**SUBJECT:** Administrative Approval for Petition No. 2016-079 NoDa Greenway One, LLC and NoDa Greenway Two, LLC

**REZONING PETITION** 2016-079 (ADMINISTRATIVE **AMENDMENT**)

**NODA GREENWAY**

**DEVELOPMENT STANDARDS**

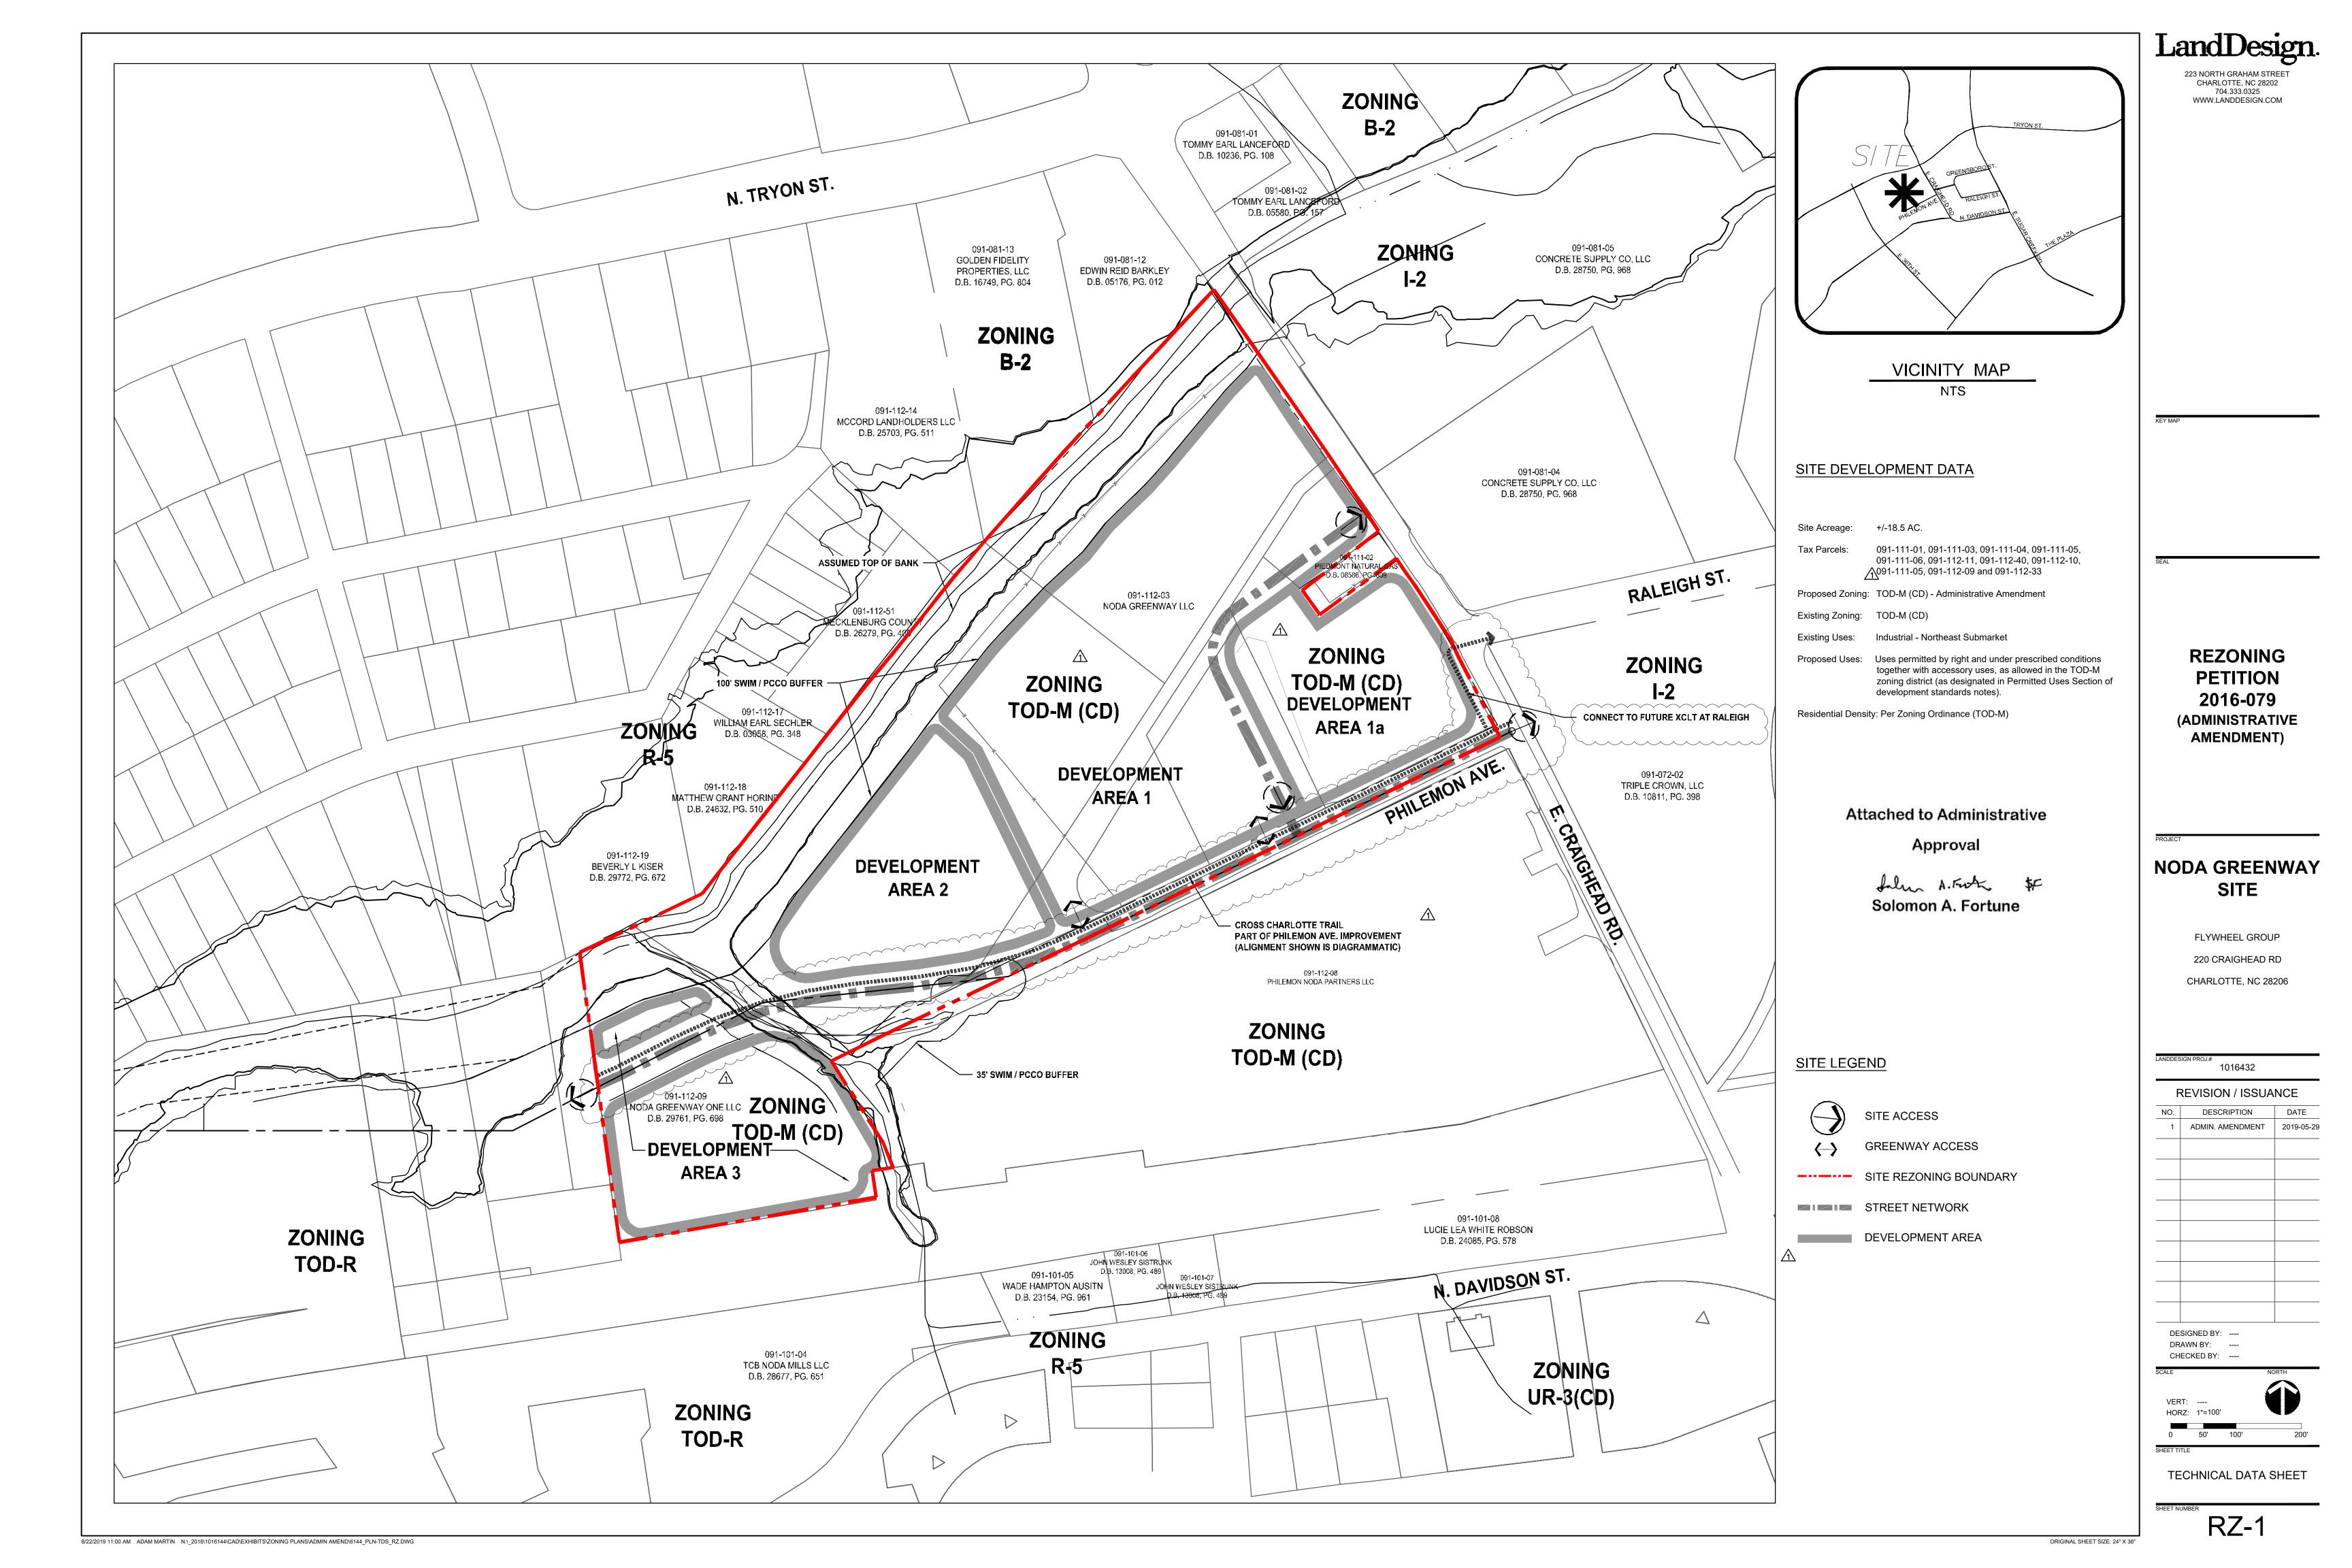
Allow a modification to the proposed location of the Cross Charlotte Trail.

Attached is the revised site plan for the petition above. This request allows the modification of the proposed site plan as listed below. Since these changes do not alter the intent of the development and meets the requirements of the Charlotte Zoning Ordinance Section 6.207 <u>Alterations to Approval</u>, minor changes, I am administratively approving this plan. Please use these plans when evaluating requests for building permits and certificates of occupancy.
